Re: Errata in Comments on Cadiz Project

Comments of
the Western Environmental Law Center
on the
Draft Environmental Impact Report/Environmental Impact Statement and
Supplement to the Draft Environmental Impact Report/Environmental Impact
Statement
for the
Cadiz Groundwater Storage and Dry-Year Supply Program

Submitted: January 8, 2001

Figure 6.
Computed drawdown (ft)
at year 100
Project halted after year 50

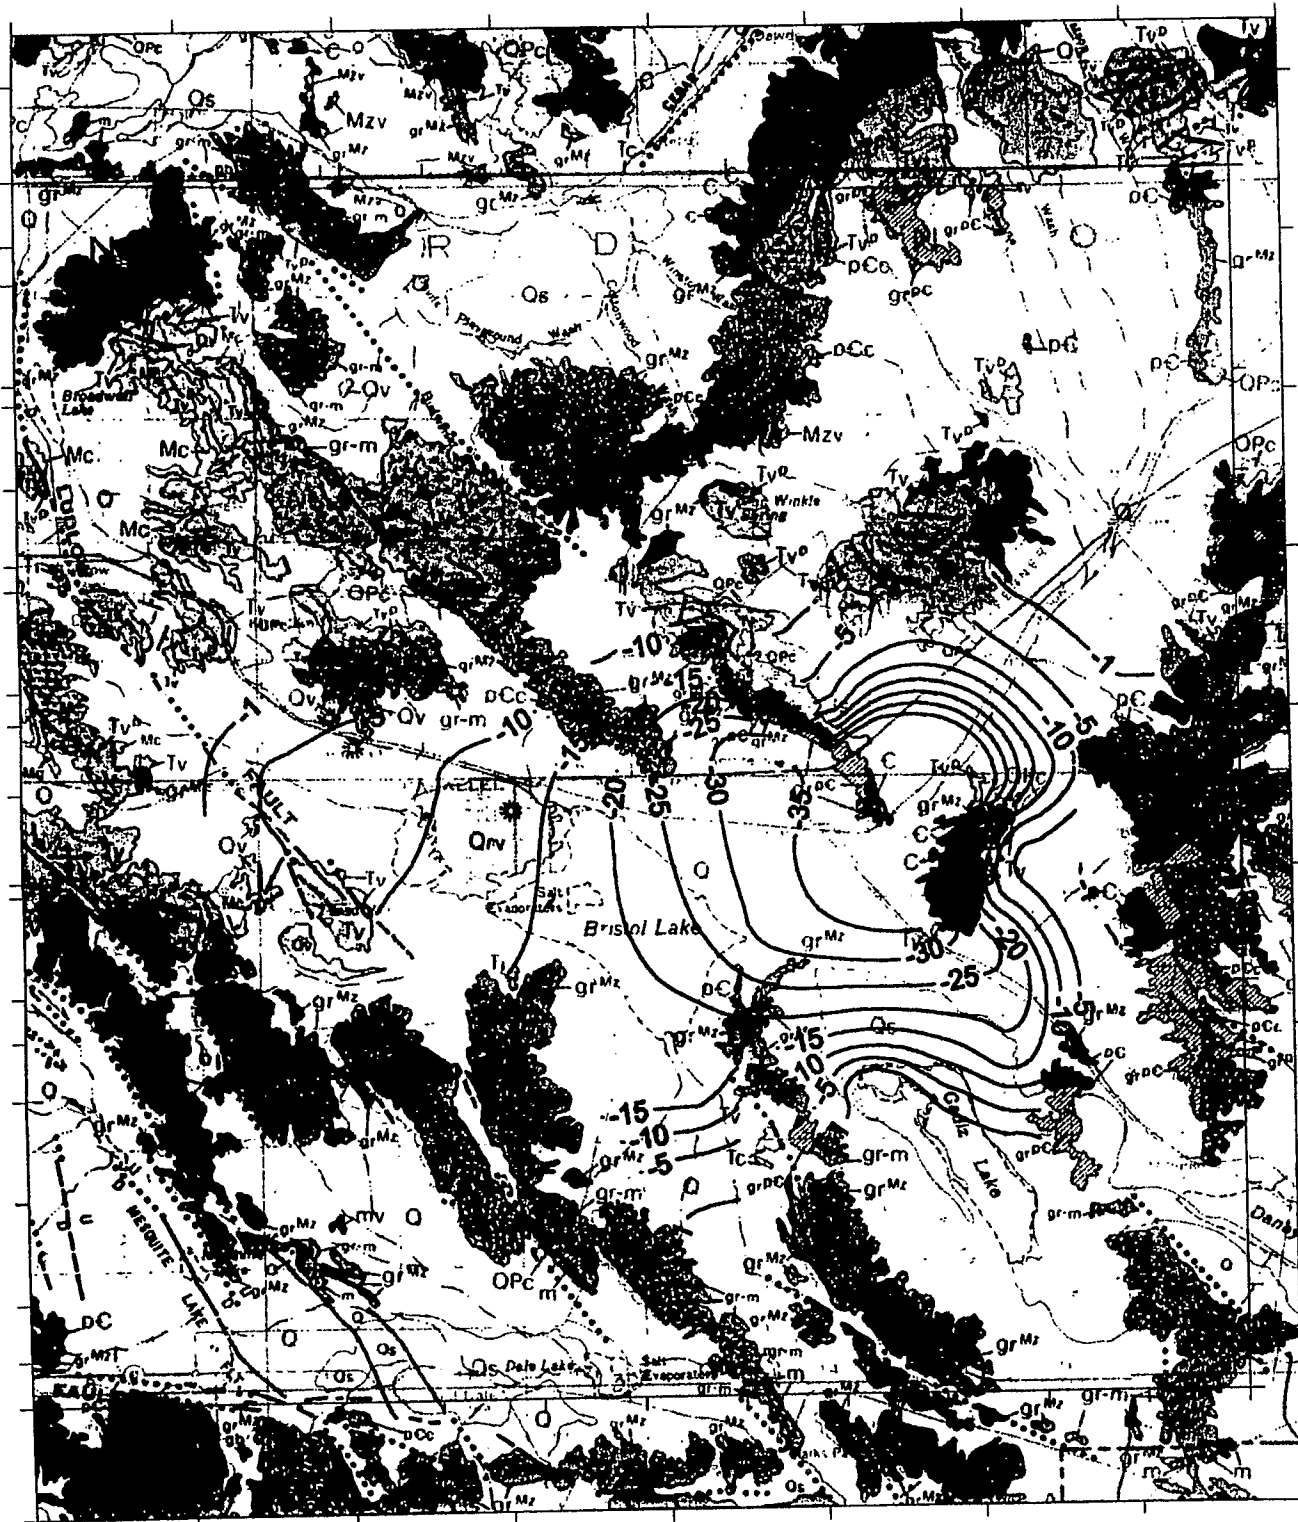
It is the response of the system after the project is stopped that shows the persistence of impacts. Figure 6 is a contour map of the drawdown at 100 years-50 years after the project is stopped. The system has recovered in the area of the project. The drawdown in this area at year 50 was more 200 feet now it is only approximately 50 feet. Figure 7 is a plot of drawdown near the project.

Figure 7. Computed drawdown near the project.

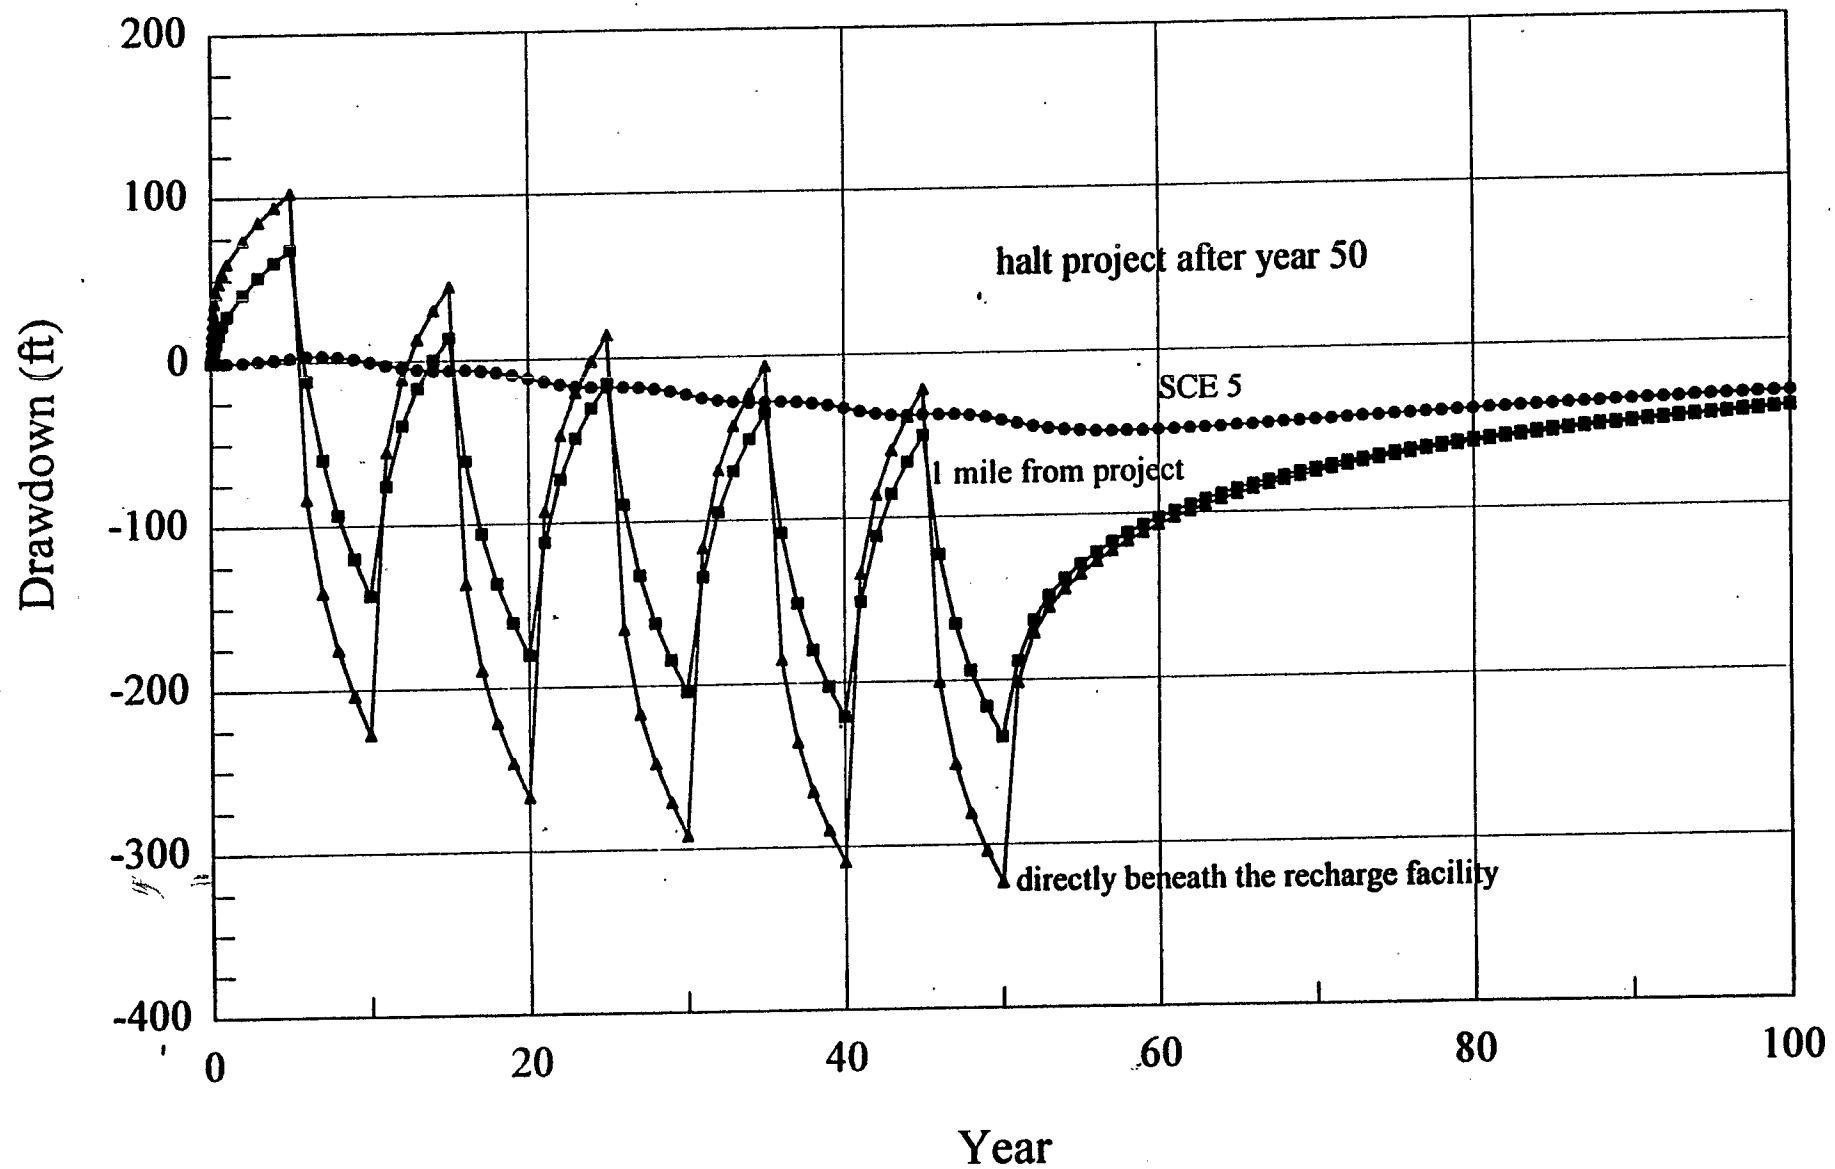
Figure 7 is the drawdown-immediately beneath the recharge pond and at 1 mile from the center of the recharge pond. The water levels beneath the facility recover, but the recovery at 100 years still leaves a drawdown beneath the facility of 50 feet. The 50 feet of remaining drawdown is largely the result of the large overdraft that the project imposes on the groundwater system. As suggested above, if the recharge to the Fenner/Cadiz valley is 5,000 to 6,000 ac-ft/yr the cone of depression will take several hundreds of years to totally refill after stopping the project.

Figure 9. Computed drawdown in three hypothetical observation wells.

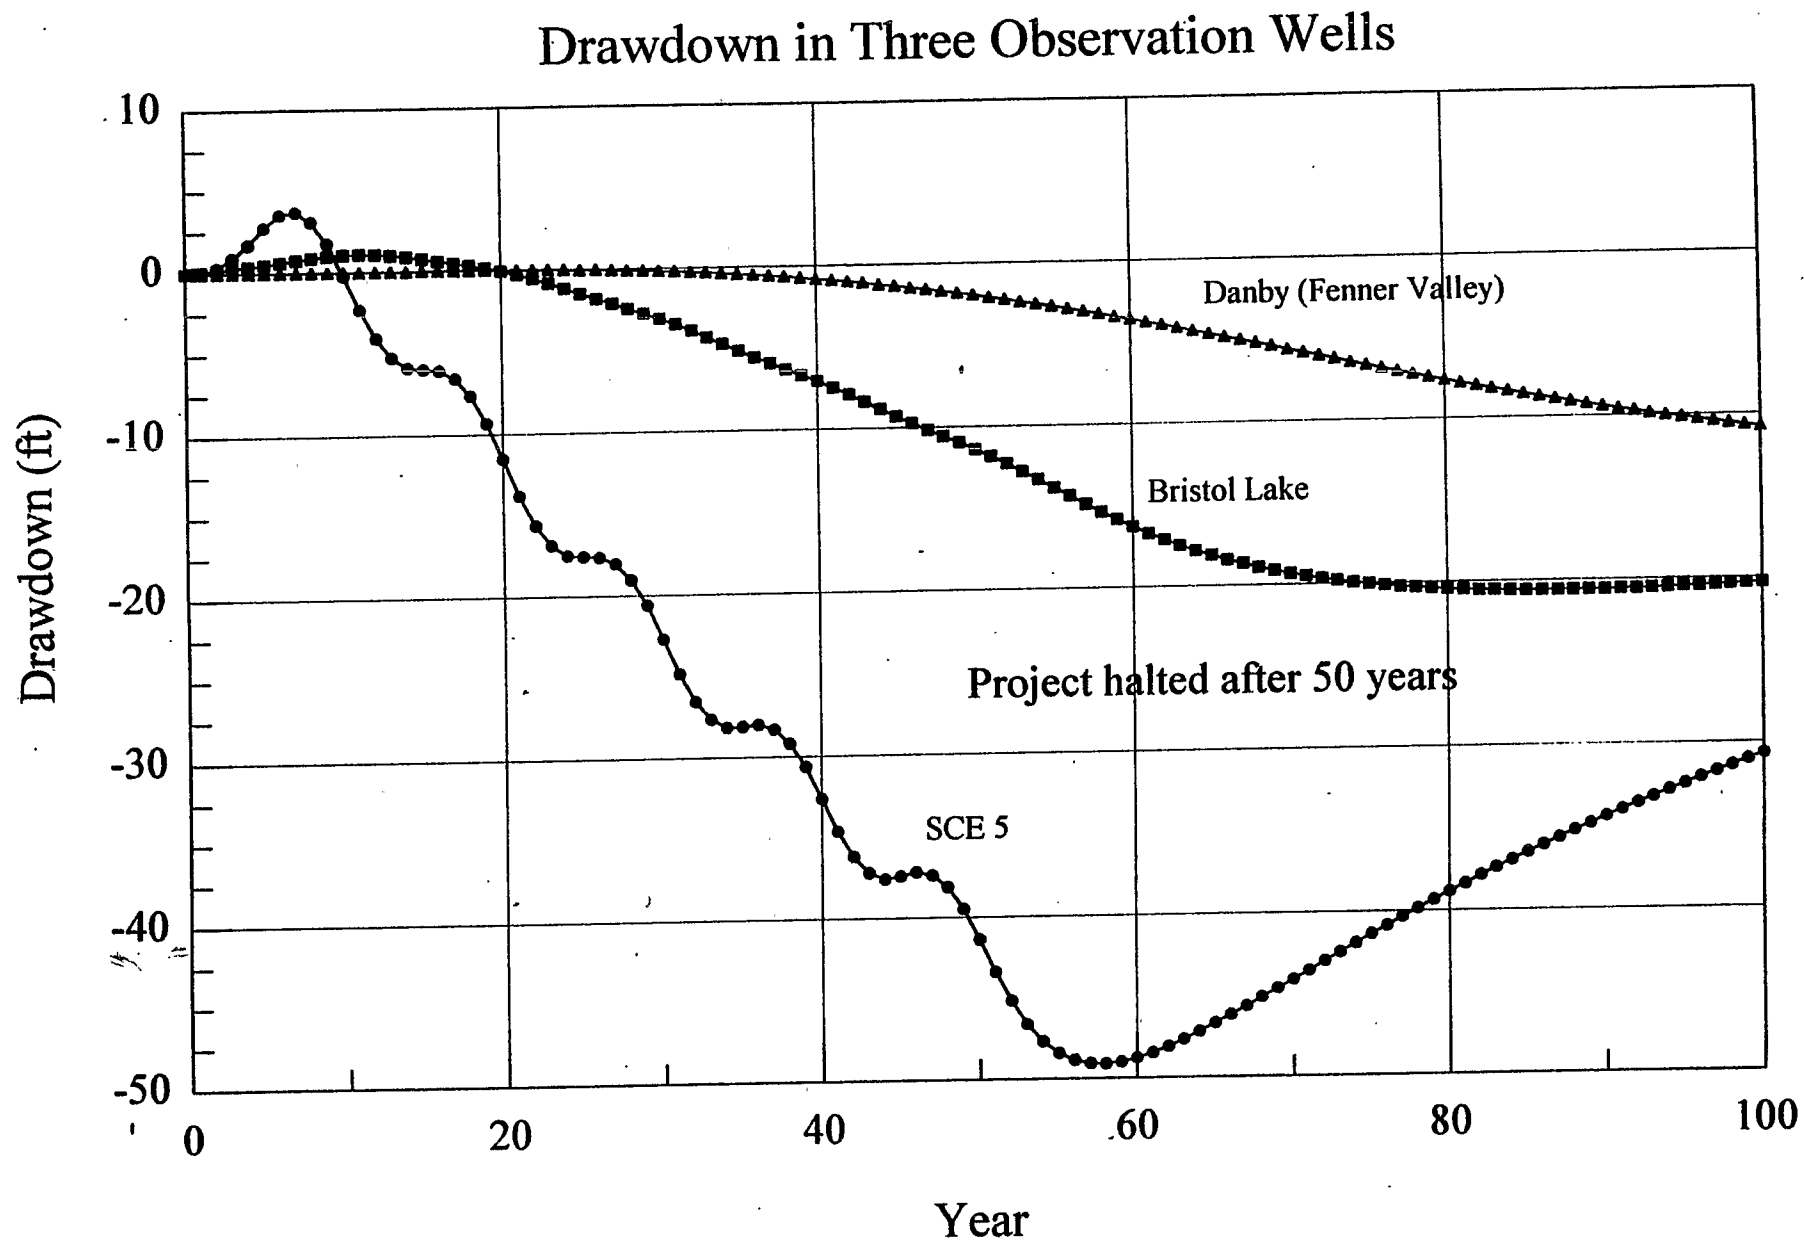
The monitoring situation is a bit clearer beneath Bristol Lake-see Figure 9. There is no decline in the water table beneath the center of the lake out to 20 years. By 30 years the drawdown is approximately 7 feet and by 50 years it is approximately 12 feet. Again this is only the beginning, the drawdown goes to 20 feet in 80 years and remains at 20 feet to 100 years. Even though the project was stopped after year 50, there is virtually no recovery in water levels beneath the lake in 100 years.

Figure 10. Computed plot of TDS in observatiion well SCE 5

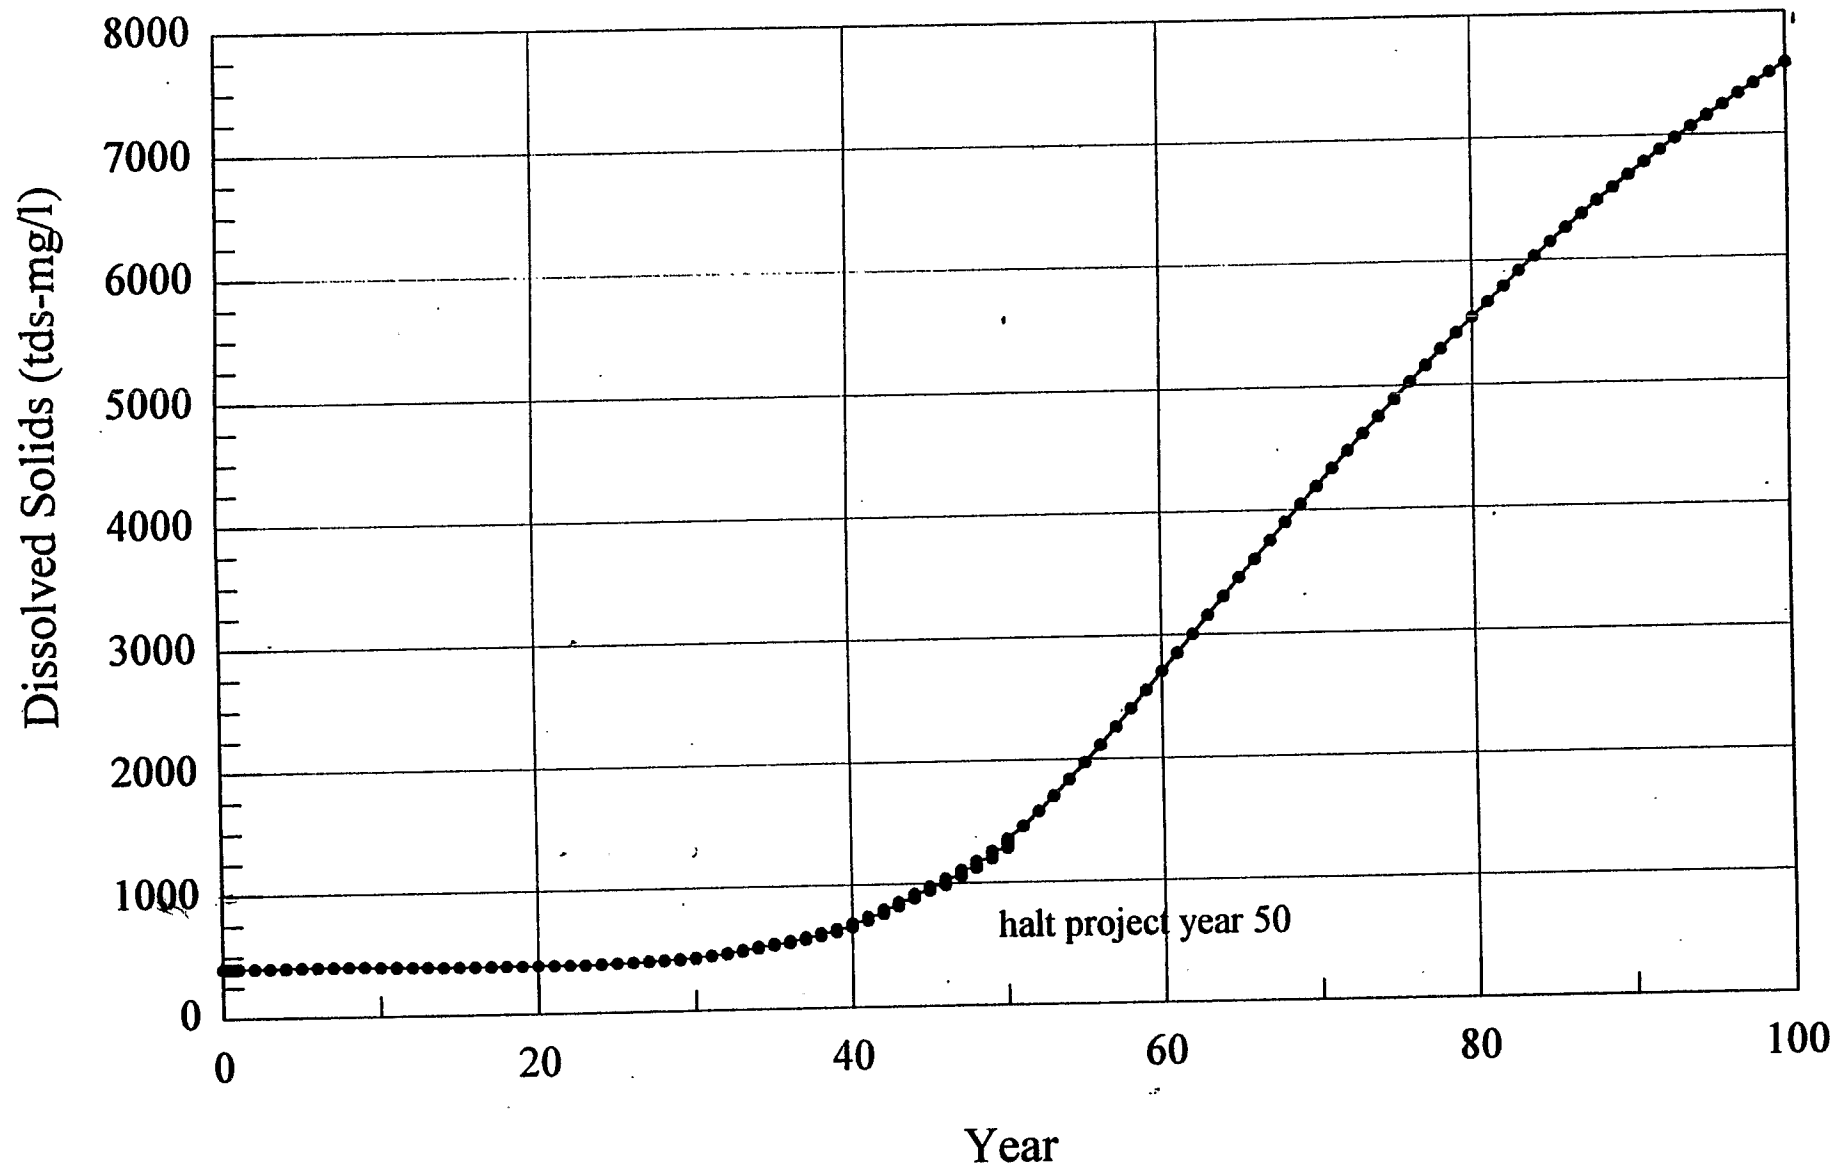
Figure 10 is a plot of total dissolved solids at the observation well SCE 5. Changes in dissolved solids do not occur at this location until the project has operated for 30 years. The total dissolved solid content reaches 1,000 milligrams per liter (mg/l) at approximately year 50. From year 50 to year 100 the dissolved solids continue to increase, at year 100 they are approximately 7,500 mg/l. The dissolved solids are continuing to increase at year 100. Figure 11 is a contour map of the simulated Bristol Lake brine distribution at year 100. One can see that the brine has migrated toward the project from beneath the lake. Again, I would caution as stated above this simulation neglects the impact of the brine density on the groundwater flow and should only be considered approximate; however, it indicates the direction of continued brine movement.

I ran the groundwater transport model to simulate the movement of the brine beneath Bristol Lake. Observation well SCE 5 is situated approximately halfway from the proposed project and Bristol Lake playa-see Figure 8. The total dissolved solids, as observed in this observation well, are plotted in Figure 10 above. Notice that the dissolved solids start to increase slightly in year 30. By year 45 it increases to 1,000 milligrams per liter (mg/l); by year 50 the concentration is 1,300 mg/l. This water is still useable; but again this is only the beginning. The concentration increases to more than 7,500 mg/l by 100 years, and it is still increasing.

Figure 11.
 Simulated Brine Distribution
 from Bristol Lake at year 100
 Project Halted after year 50
 Contours in TDS (mg/l)

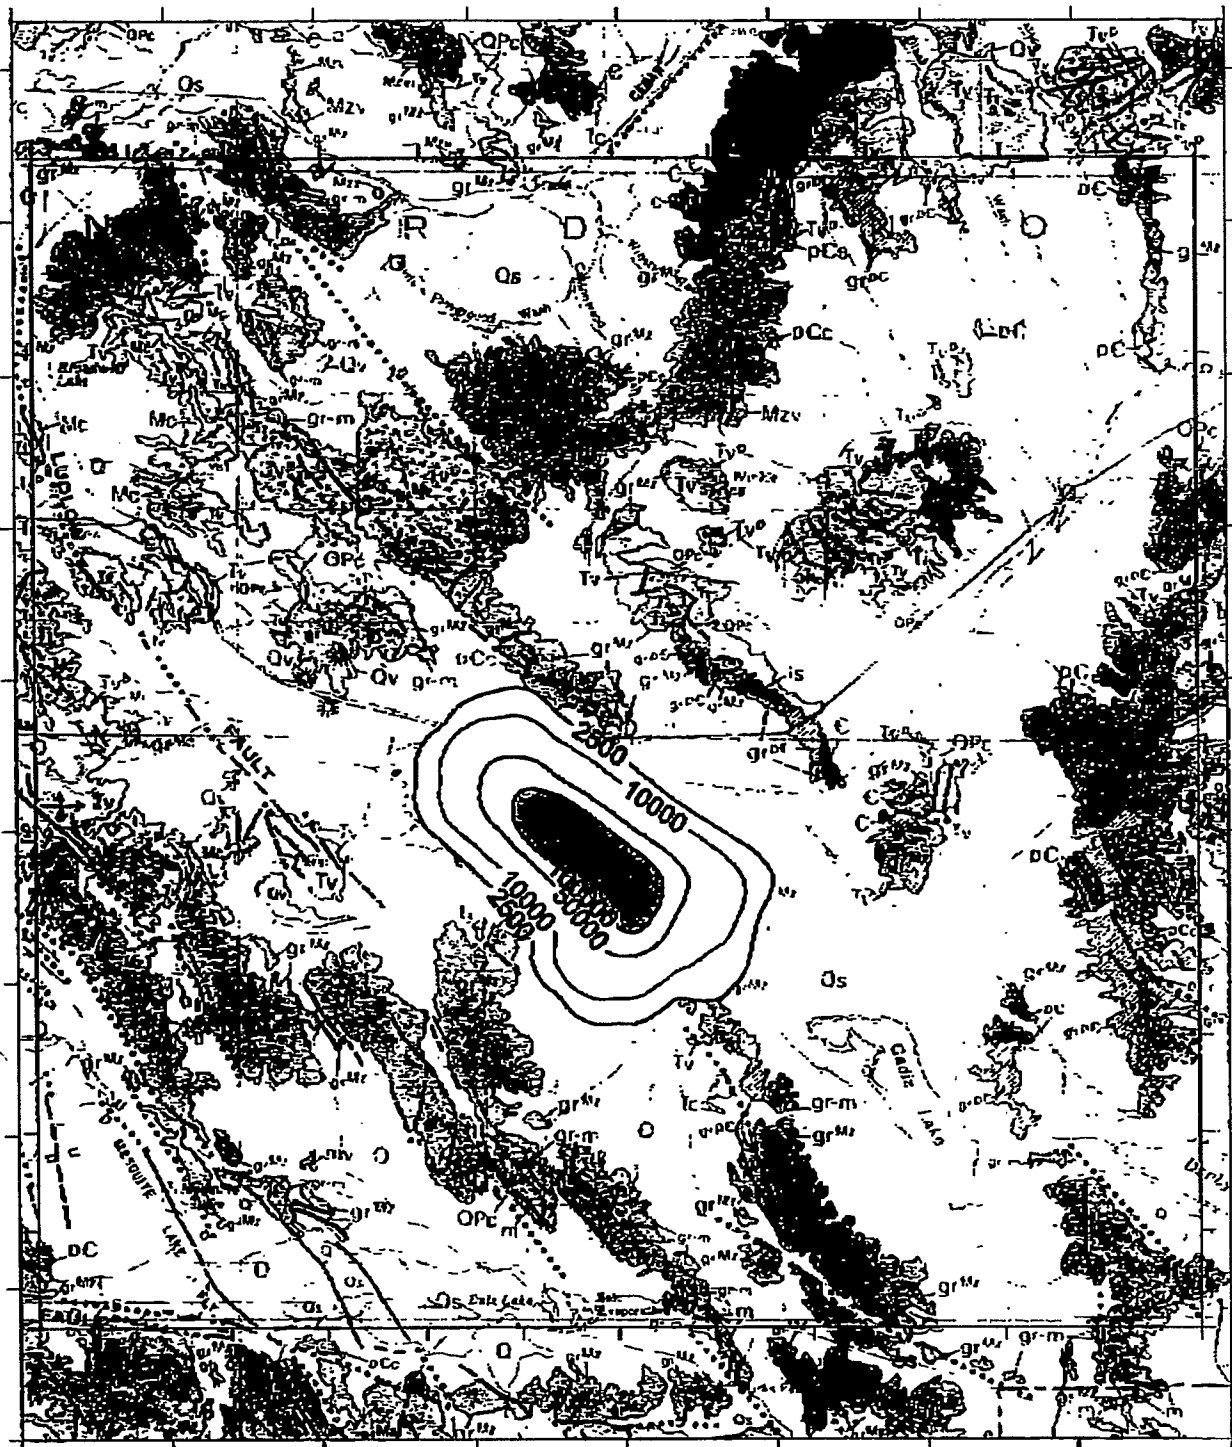
Second, figure 11 was inadvertently left out of the figures attached to Dr. John Bredehoeft's report, which is the first attachment to Law Center's comments.

Enclosed with this letter is a copy of figure 11 from Dr. Bredehoeft's report and a revised page 1 of the Law Center's comments with a corrected list of the organizations making up the coalition on whose behalf the comments are submitted.
